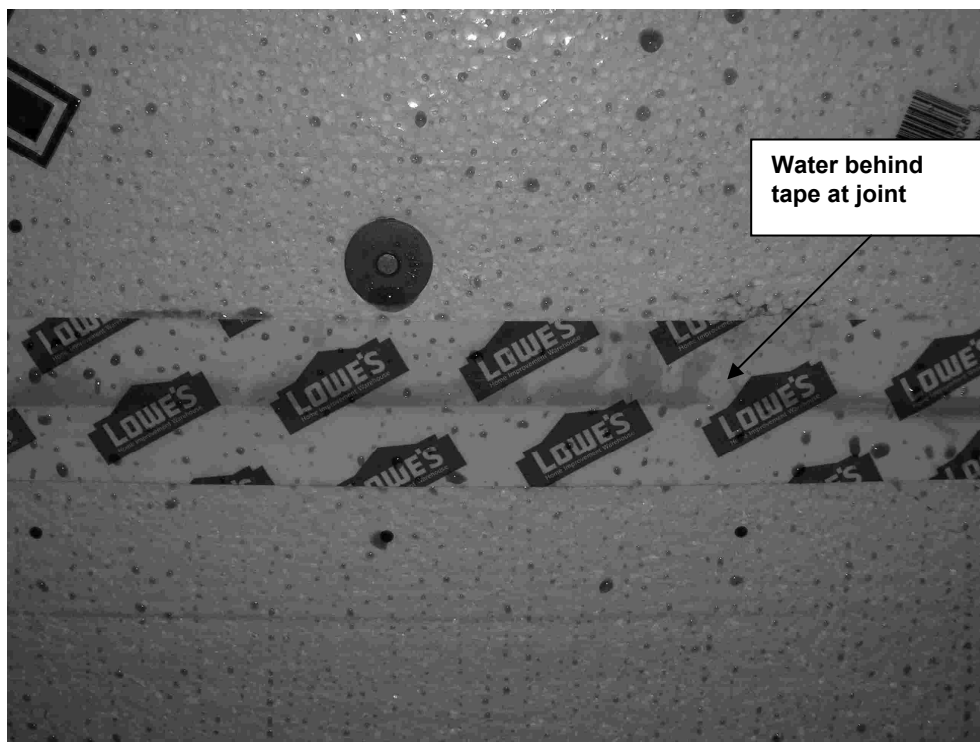
In our laboratory we conducted some initial tests on the performance of taped insulating sheathing wall assembly which passed the criteria in the proposal after exposure to thermal cycling. Walls assemblies were tested by the ASTM E331 criteria in the proposal, then exposed to 5 cycles of thermal cycling between 120°F and 32°F and retested by the ASTM E331 procedure. The results are shown in the table below.

Sheathing butt joints were observed to enlarge up to 1/8 inch. A typical failure is shown using colored water in the figure below. Loss of tape adhesion resulted in water intrusion behind the tape collecting at and ultimately intruding through the panel joint.

**FIGURE R804.1.2
IN-LINE FRAMING**

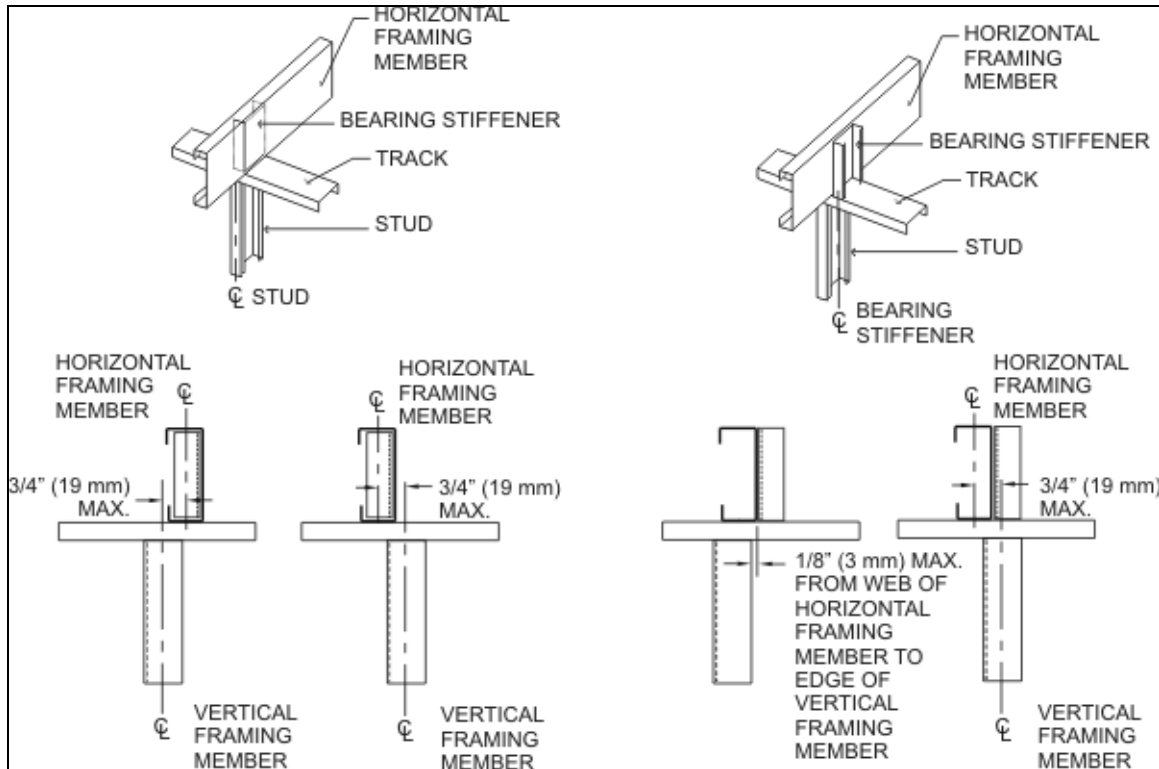
23. Add new figure as follows:

Section R804.1.2: The 2007 edition of AISI S230 references the 2007 edition of AISI S200 (*North American Standard for Cold-Formed Steel Framing—General Provisions*) which has revised the in-line framing tolerance to account for the special case of the bearing stiffener located on the back-side of the joist. This was based on research at the University of Waterloo (Reference: Fox, S.R. (2003), "The Strength of Stiffened CFS Floor Joist Assemblies with Offset Loading," American Iron and Steel Institute, Washington, D.C.)

R804.1.2 In-line framing. Cold-formed steel roof framing constructed in accordance with Section R804 shall be located directly in line with load-bearing studs in accordance with Figure R804.1.2 and the tolerances specified in Section R804.1.2(a) or R804.1.2(b) and with Figure R804.1.2 as follows:

FIGURE R804.2.5.3
WEB HOLE PATCH

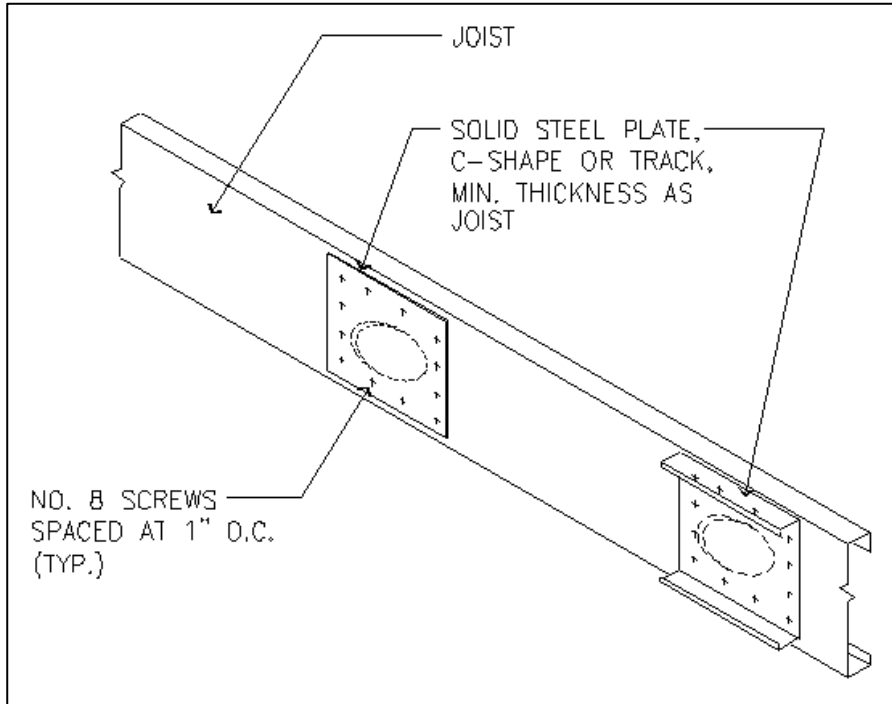
25. Add new figure as follows:

Section R804.2.5.3: This language has been relocated from Section R804.3.6 in order to improve the clarity and usability of the code. Modifications have been made to the charging language to reflect the fact that the user now has the choice to reinforce non-conforming holes, patch non-conforming holes, or design non-conforming holes with accepted engineering practice per Section R804.2.5.1. Additionally, Figure R804.2.5.3 has been added as an update to the old Figure R804.3.6, in order to coordinate with AISI S230-07.

**FIGURE R804.3
STEEL ROOF CONSTRUCTION**

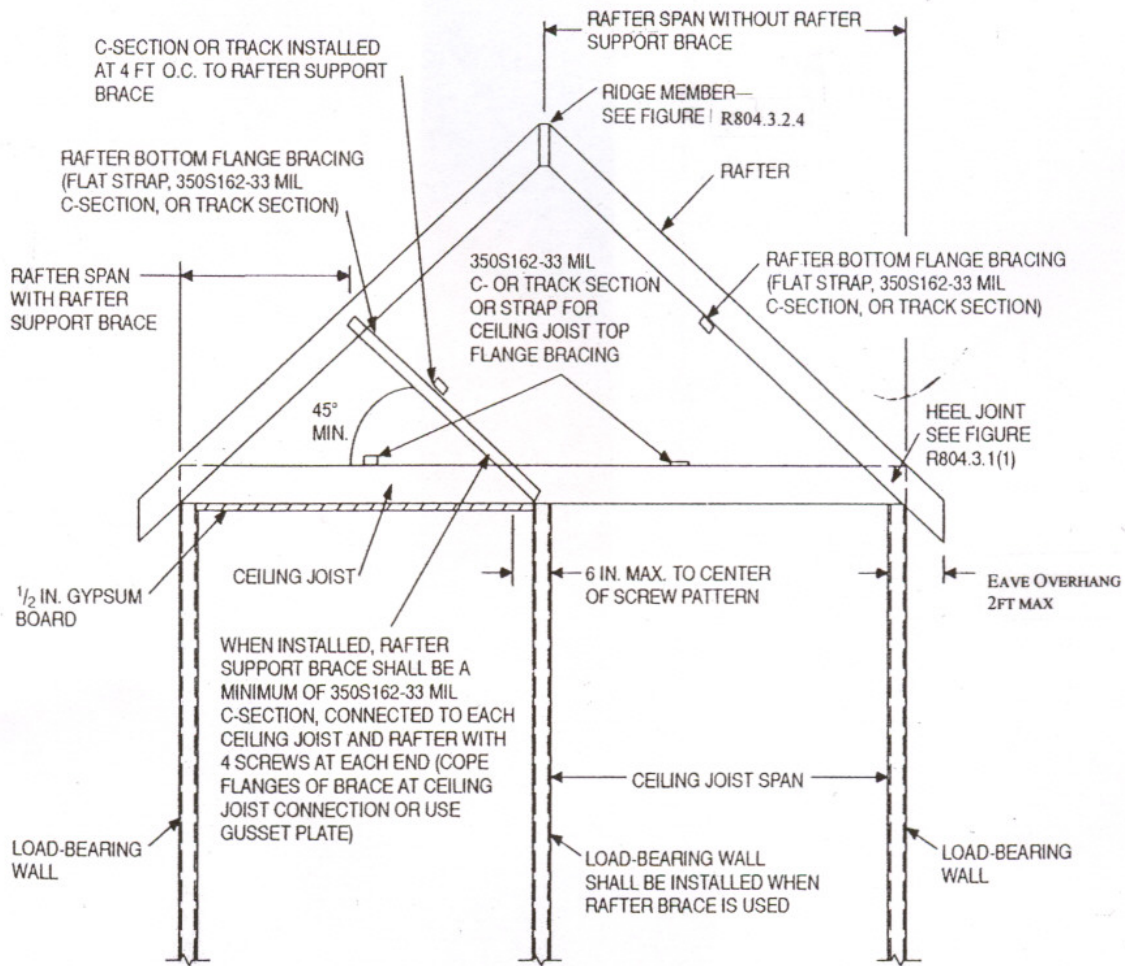
26. Revise as follows:

FIGURE R804.3.1.1(1)
JOIST TO RAFTER CONNECTION

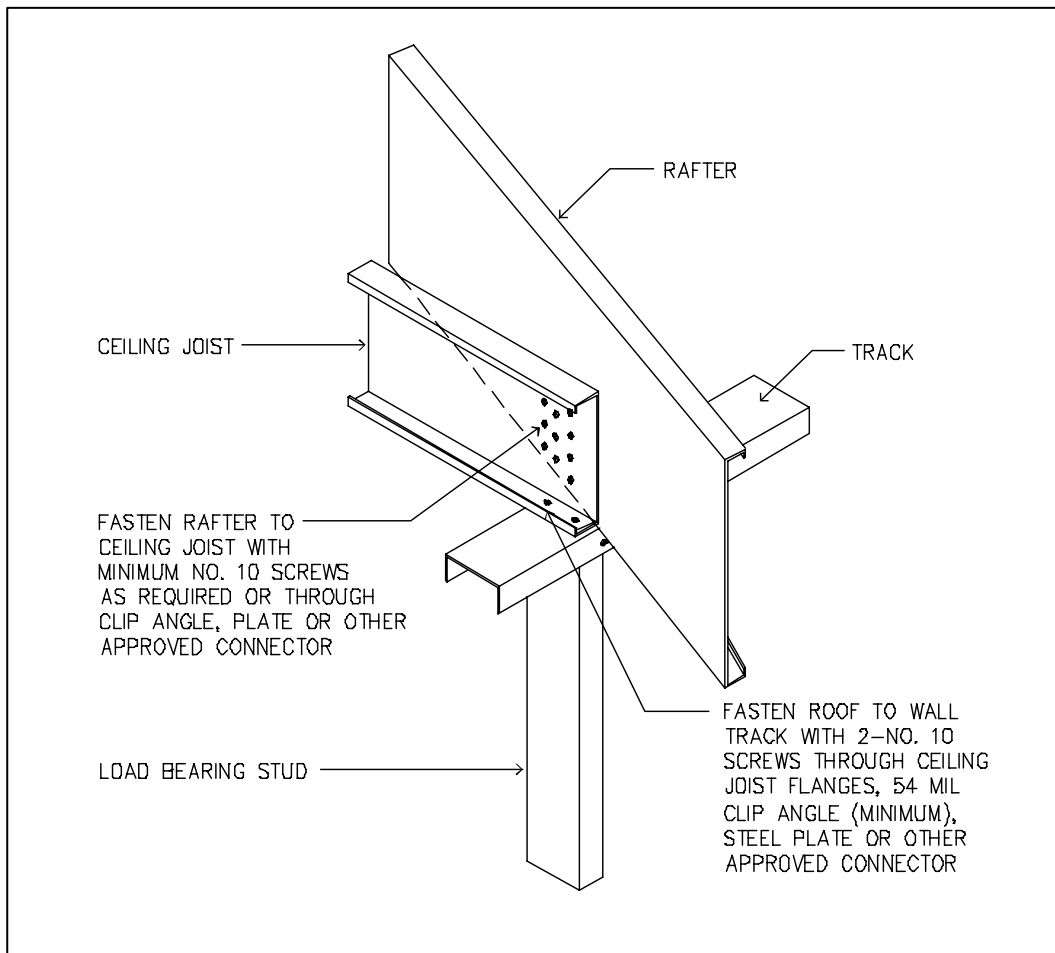
27. Delete existing Figure R804.3.1(1) and replace as follows:

FIGURE R804.3.1.1(2)
BEARING STIFFENER

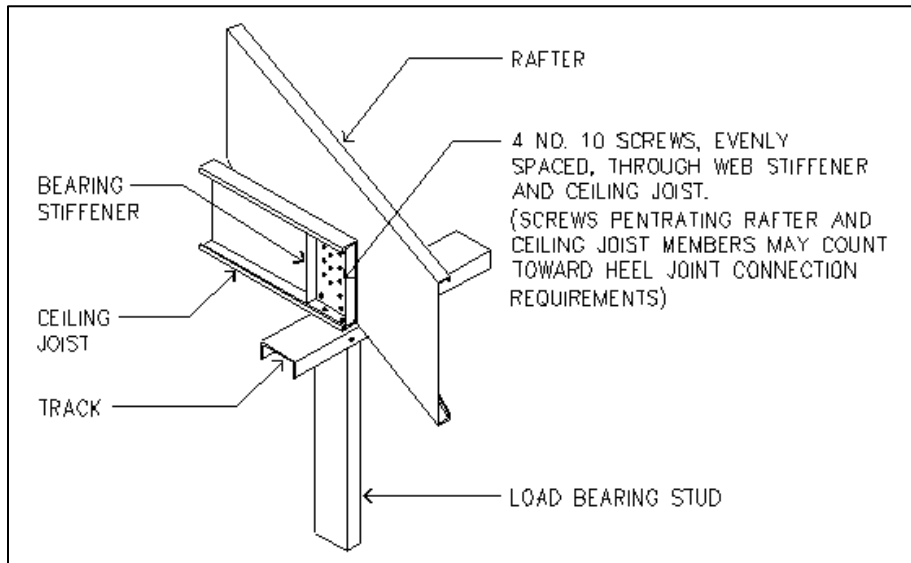
28. Add new figures as follows:

Section R804.3.8: This section on bearing stiffeners has been updated extensively and relocated to the section on ceiling joists. As a result of this change, subsequent sections have been renumbered for coordination.

FIGURE R804.3.1.4(1)
CEILING JOIST TOP FLANGE BRACING WITH C-SHAPE, TRACK OR COLD-ROLLED CHANNEL

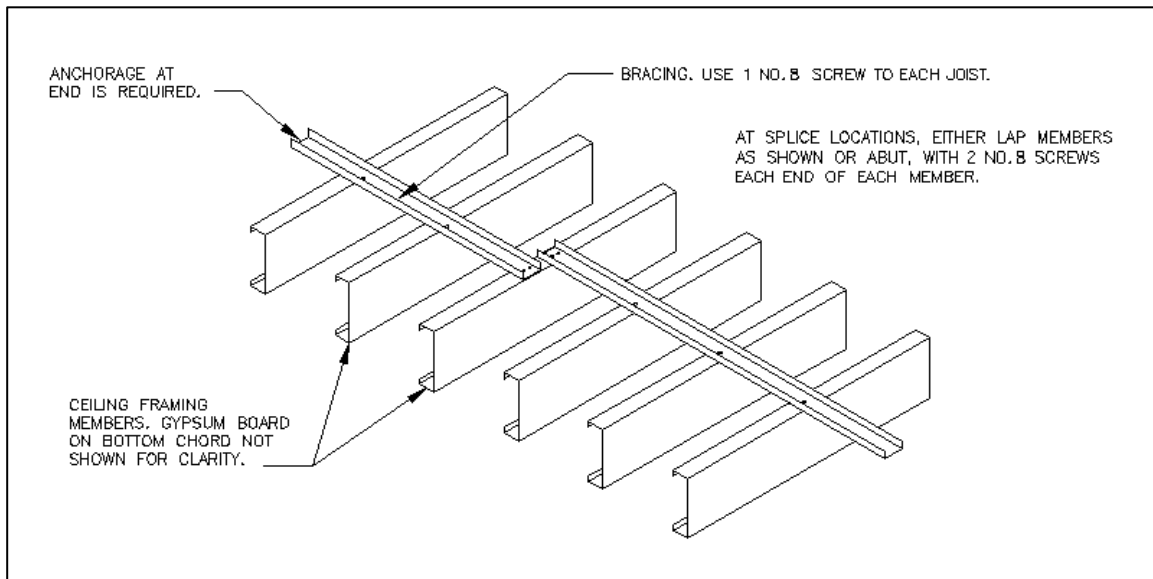
Figures R804.3.1.4(1) and R804.3.1.4(2) illustrate new options for ceiling joist top flange bracing.
 Figure R804.3.1.5 illustrates a new detail for spliced ceiling joints from AISI S230-07.
 Figure R804.3.2.1.2 illustrates gable end wall and outlookers overhang details.
 Figures R804.3.2.4 is a replacement figure that illustrates newer information on screw types and cross section details for clarity.
 Figures R804.3.3.4(1) through R804.3.3.4(5) are new figures that correspond to the new hip roof provisions for this proposal. These include various views for the construction of hip roof intersections with the building framing (e.g. walls, ceiling joists, and rafters).
 Figure R804.3.6(2) illustrates a new header to trimmer connection.
 Figures R804.3.8(1) through R804.3.8(3) are new figures that illustrate cross-sections of the intersection of the ceiling diaphragm with the perimeter wall. These figures correspond with new Section R804.3.8.

**FIGURE R804.3.2.1.2
GABLE ENDWALL OVERHANG DETAILS**

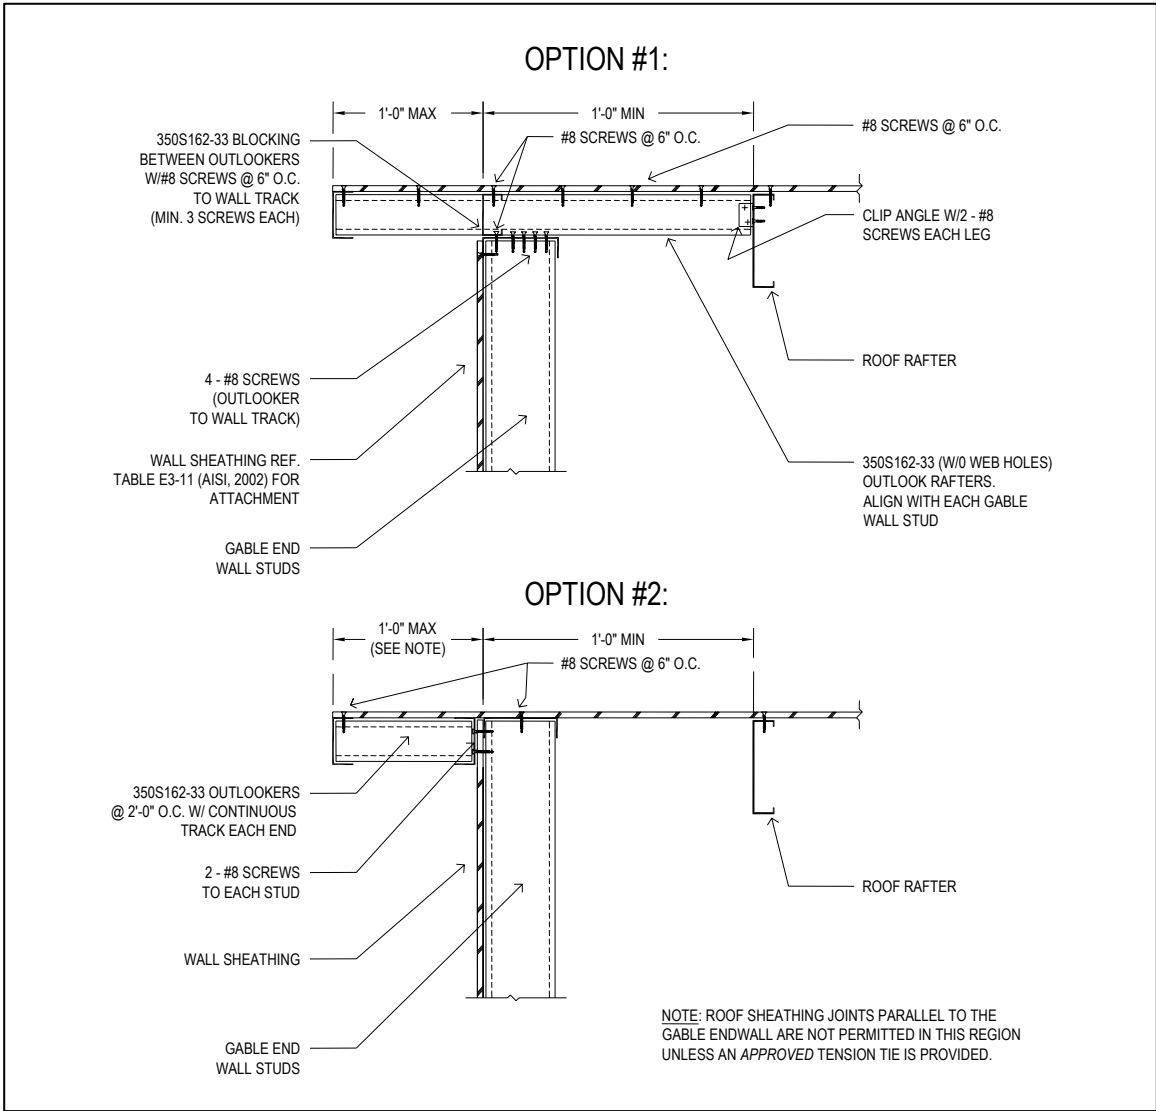
Section R804.3.2.1: New sub-sections on eave overhangs and rake overhangs have been added. The section on rake overhangs addresses the lack of information on this subject in previous editions of the IRC and coordinates with AISI S230-07. In addition Figure R804.3.2.1.2 has been added to supplement this provision. Accordingly, Section R804.3.3.2 on roof cantilevers has been recommended for deletion.

FIGURE R804.3.2.43.1
HIP MEMBER OR RIDGE BOARD MEMBER CONNECTION

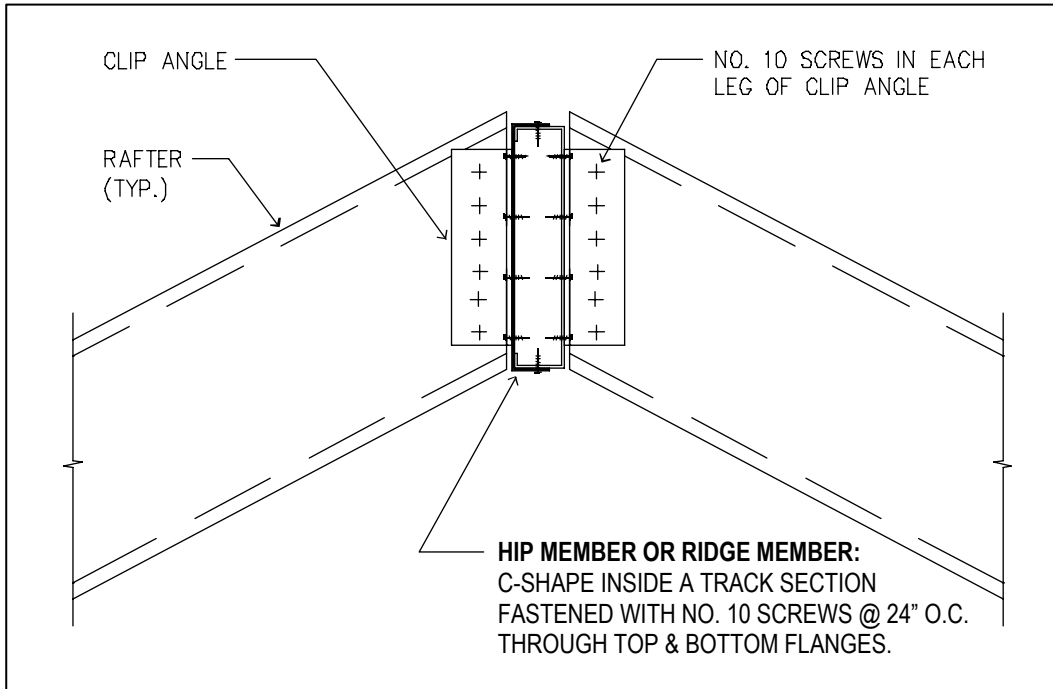
29. Revise as follows:
